**THE HIGHLAND COUNCIL**

**NORTH PLANNING APPLICATIONS COMMITTEE**  
**4 August 2015**

**14/00016/FUL : Mr Brian Elias**  
**Land to North East of Glen View, High Street, Conon Bridge**

**Report by Area Planning Manager**

**SITE PLAN. Scale : 1 to 250.**

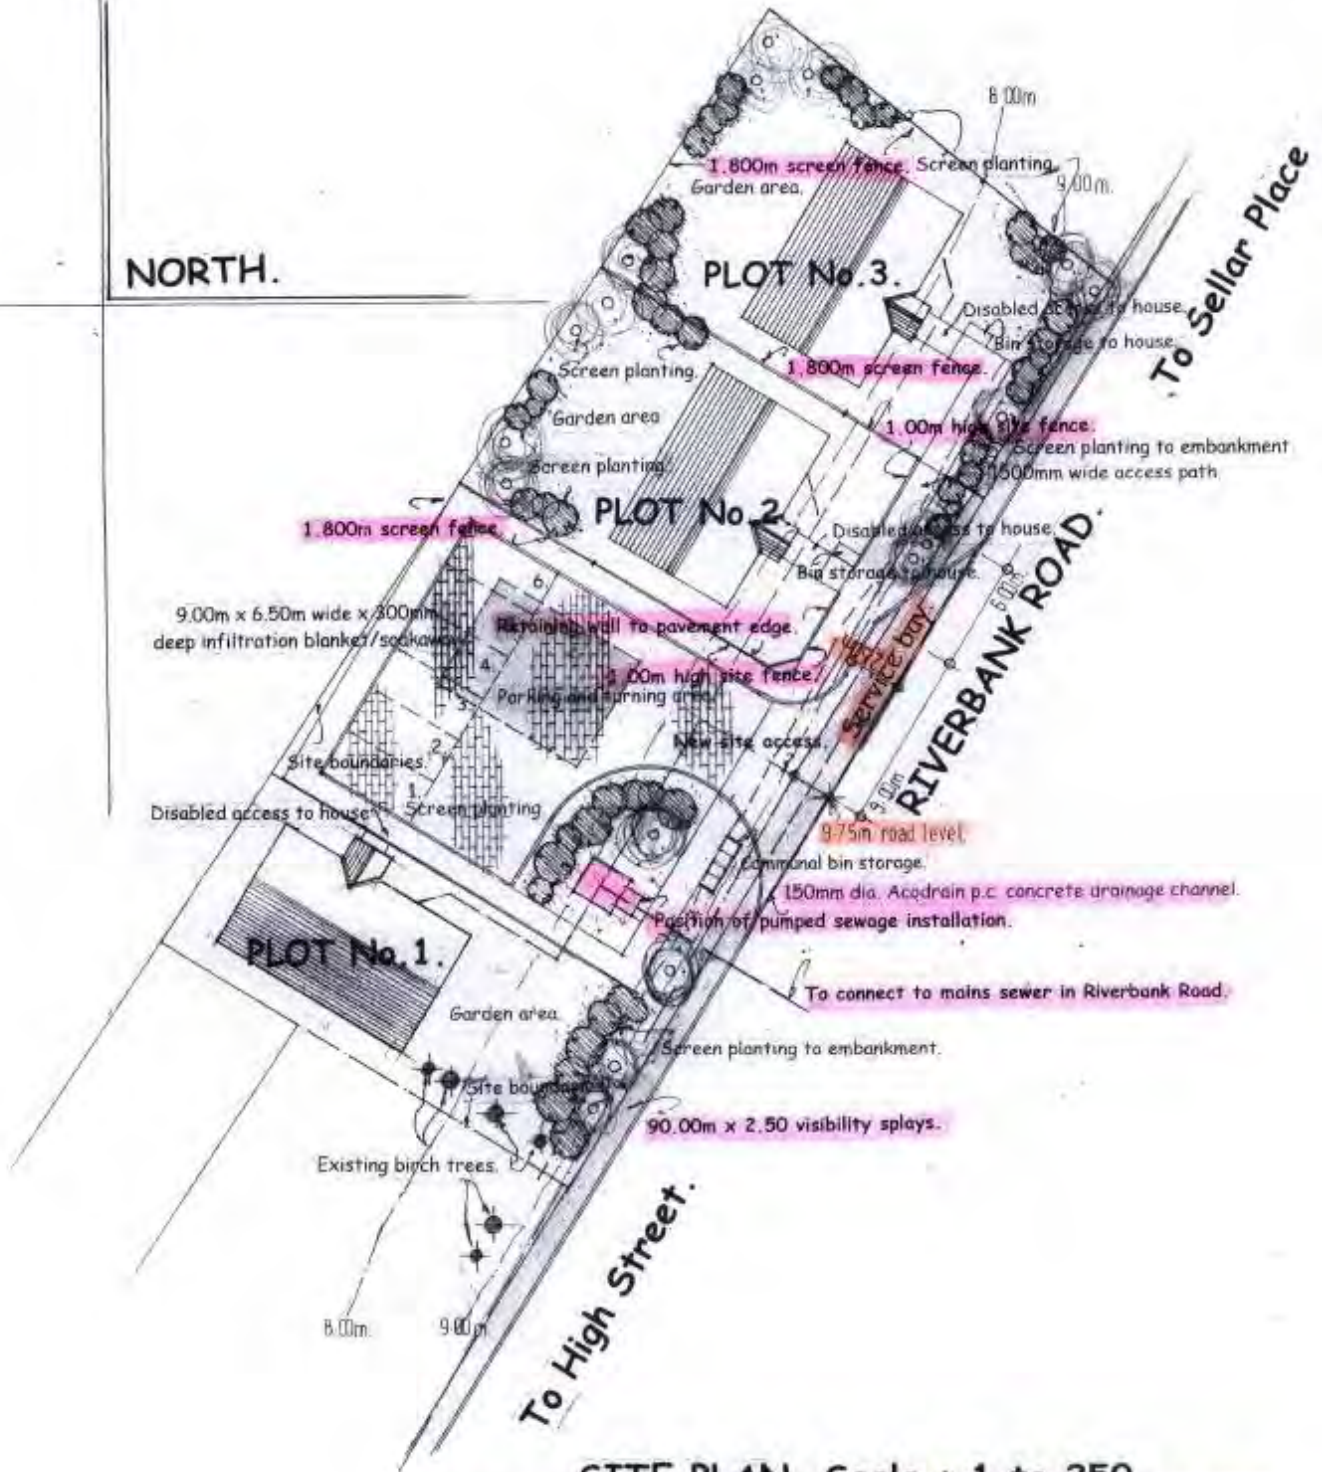
The proposed houses on Plots 2 and 3 have their main elevation towards Riverbank road. The access to the site leads to a parking court for all of the proposed houses, which is sited between Plot 1 and Plot 2. Plot 1 has been orientated to face the parking court, with its gable towards Riverbank Road. The houses are all single storey two bedroomed properties, and the layout facilitates passive surveillance of the communal space/car parking whilst maintaining a relationship with Riverbank Road.

8.3.16 Plots 2 and 3 have rear gardens of approximately 7.5m in length, with a screen fence to the rear boundary. Although this is less than the proportions normally expected from a rear garden, given the small size of house and use of the land to the rear as a field, in this instance this is considered satisfactory. The single storey height of the houses and a screen boundary fence will guard against potential overlooking of the land to the rear, and enable the houses to be satisfactorily absorbed into the site.

8.3.17 Plot 1 has a blank gable towards the rear site boundary. Although it is only approximately 2m from this boundary, in this instance it is unlikely to raise issues of massing or overlooking. Similarly, Plot 1 is located only 1.5m from the side boundary (with the rear gardens to houses on High Street). A screen boundary fence is proposed which will help protect the privacy of these properties. The rear gardens to the houses on High Street are of a substantial length, and there are assorted outbuildings close to the boundary with the site, which will also help to preserve amenity. The house on Plot 1 is also designed with only one secondary window in the rear elevation towards the garden grounds of the houses on High Street, and the main lounge window/patio doors opening onto the garden grounds between the Plot 1 house and Riverbank Road, which will give a pleasing aspect to the occupiers of this house.

A letter of representation was received from the residents of Riverbank Road (9 signatures), raising objections to the original proposal. No comments were received following the submission of amended plans. One of the grounds for objection was that the entrance/exit to the site was unsuitable and would result in disruption to householders directly opposite the proposed access. The access point has now been moved further northeast along Riverbank Road, but is still opposite some of the existing houses.
